# Green and Golden Bell Frog Plan of Management for the M6 Stage 1

Prepared by AMBS Ecology & Heritage Pty Ltd  
for CPB Contractors Pty Limited and Ghella Pty Ltd

Document Number M6S1-CGU-NWW-EO-PLN-000426

Consultation with the Environment, Energy and Science Group (EES) was undertaken in September 2021 and a table indicating how their comments have been addressed is provided in Appendix B.

**Figure 1.3: Locations where GGBFs were recorded between January 2020 and May 2021.**

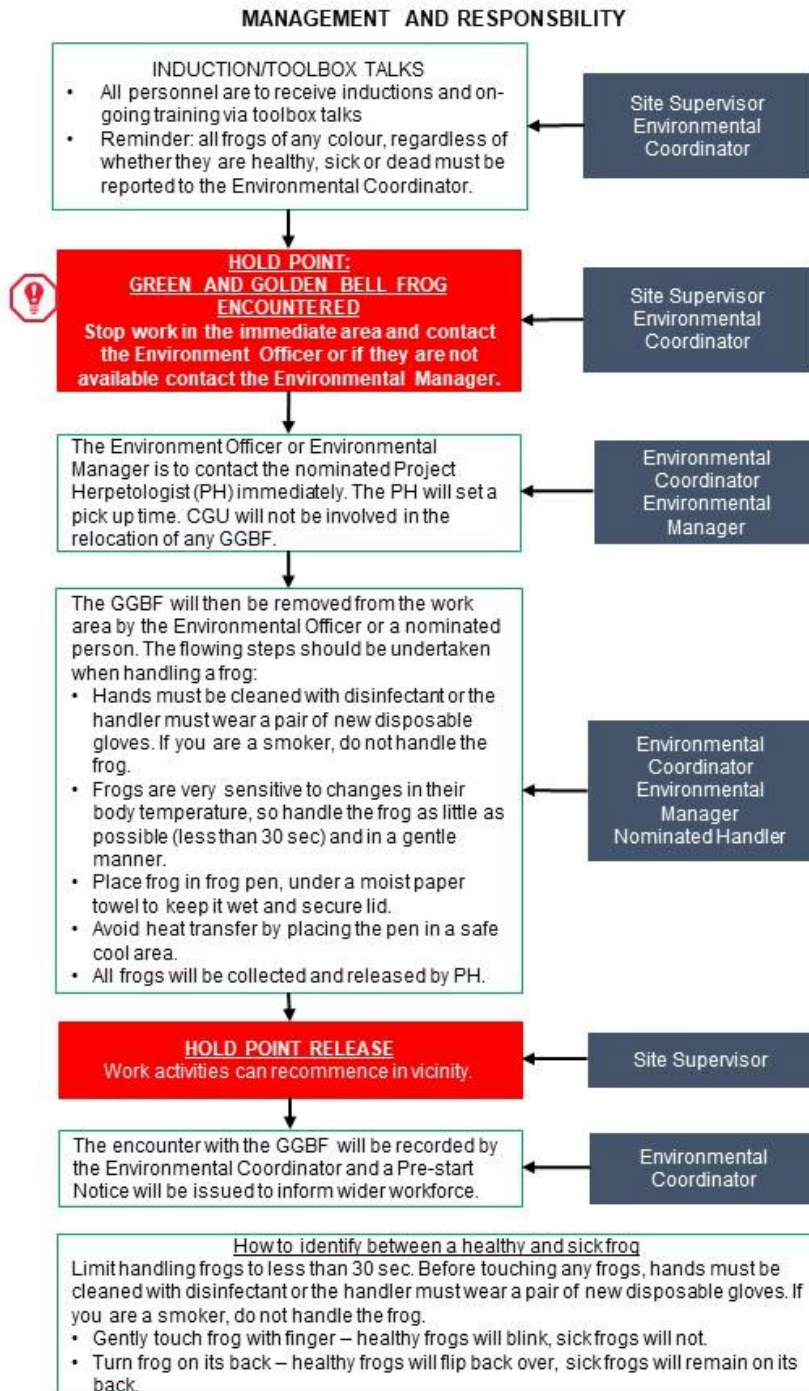
Section	Comment	Response
1.2	Figure 1.3 should be made consistent with Figure 1 of the most recent report <i>Green and Golden Bell Frog Monitoring, Arncliffe, September - November 2020</i> by AMBS Ecology & Heritage, 2021 (shown below), by identifying all of the features referred to in the plan and their boundaries/extents. At the least, all the areas or features mentioned in the plan should be shown. 'Barton Park', the 'Eastern Frog Corridor', the extent (boundary) of the 'Enhancement Area' and the individual ponds within the Enhancement Area are referred to in the plan but are currently not shown in Figure 1.3.	Figure 1.3 has been updated to identify the locations of the features referred to in the plan, with some exceptions and caveats. In relation to the Enhancement Area, the boundary is not shown on Figure 1.3 because the boundary has not been defined, and Figure 1 of the monitoring report shows the approximate area covered during spotlighting surveys, rather than the actual frog habitat, which is a much smaller area. References to the 'Eastern Frog Corridor' have been changed to 'underpass', consistent with the terminology used in the management plans prepared for the M8.
